Staff Report Date: 07.20.2020

## 2 Bethesda Metro Center, Site Plan Amendment 81989060D

- Site Plan Amendment: Request to convert 8,999 square feet of office into a daycare center for up to 112 children, decrease public use space by 1,775 square feet to create a play area for the new daycare, and modify hardscape and planting;
- Location: Northeast quadrant of the intersection of Woodmont Avenue and Montgomery Lane, above the Bethesda Metro Station;
- Zone: CBD-3 (CR-8.0 C 8.0 R 7.75 H-250') and the Bethesda Overlay Zone;
- Master Plan: 2017 Bethesda Downtown Sector Plan:
- Property size: 1.14 acres;
- Applicant: Bright Horizons Childrens Center, LLP;
- Acceptance Date: March 17, 2020;
- Review Basis: Per Section 59.7.7.1.B.3, Pre-2014
   Zoning Ordinance.

Figure 4 – Proposed Rendered Site Plan Amendment

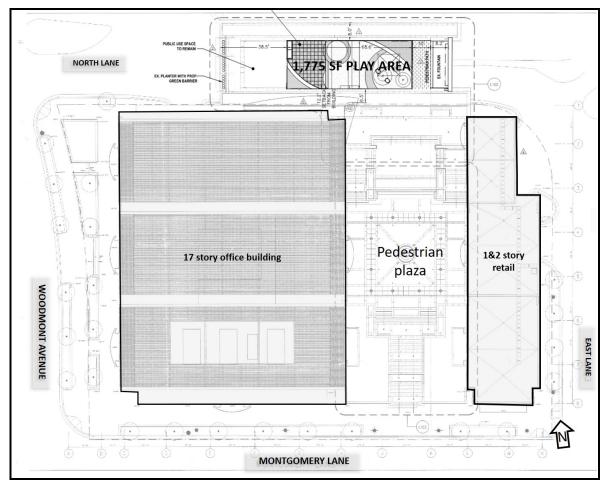
The Applicant requests to reduce public use space by 1,775 square feet to allow for a play area associated with the proposed daycare. This space will be located near the front entrance of the building on the second story plaza and the design is integrated into the existing plaza through modification of the existing pavers, providing low fencing, and maintaining clear paths for proper circulation around the play area. The play area will be reserved for the daycare center during operating hours, however it will remain open to the public outside of those operating hours.

The Applicant also proposes to install a vegetated wall over the existing concrete overlook wall to North Lane for safety purposes. The vegetated wall will be a maximum of 2' in height bringing the entire overlook wall to a maximum 5.5 feet in height.

Figure 5 – Proposed Daycare play area layout

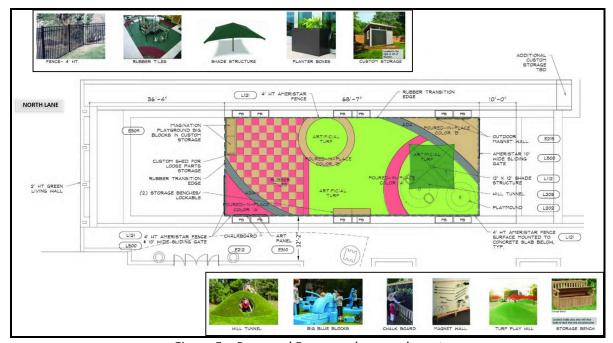
- f. Shift play area 5-feet west to maintain a minimum pedestrian travel way of 15-feet between play area and existing fountain;
- g. Add dimensions to the overlook wall and proposed vegetated barrier, not to exceed 2 feet in height, for a total wall height of 5.5 feet.

The main walkway of the plaza is approximately 30-35' in width, and the placement of the play area will impede into the existing walkway, however Staff has conditioned that the Applicant shift the play area 5-feet west to maintain a minimum pedestrian pathway of 15', which is consistent with through block connections in the surrounding area. The play area will be wrapped in a 4' aluminum fence that is screened with several planters and contain a synthetic turf mound with play tunnels, rubber tile surfacing, shading elements, and other play elements, see Figure 5.
